**Symptom - Body Exterior - Headlights Have Interior Condensation: Reworking headlights (SY 04/15)**

Model Line: **Macan (95B)**

Subject: **Headlight**

*Air vent nozzle*

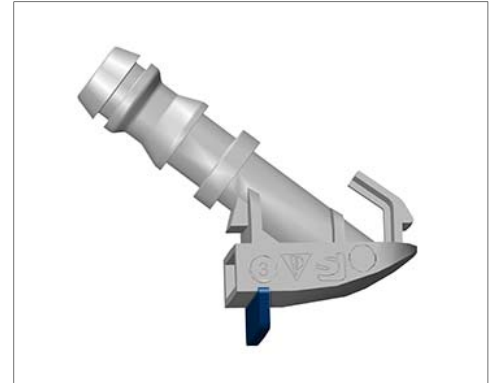
**Cause 2:** Headlight ventilation is not sufficient because an air vent nozzle without an injection-molded rubber lip was installed.

The air vent nozzles without an injection-molded rubber lip must be replaced at the left and right with air vent nozzles with an injection-molded sealing lip (Part No. **95B.941.741.A**). ⇒ *Air vent nozzle*

*Installation position of breather hose*

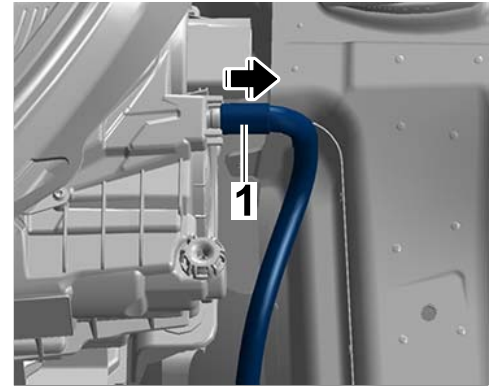
**Cause 1:** The ventilation system does not work properly because of a kink in the breather hose.

**Remedial action 1:** The breather hose 95B.941.560.**B** (without corrugated hose) must be replaced by the breather hose 95B.941.560.**C** (with corrugated hose).

It is important to check that the breather hose is routed without kinks.
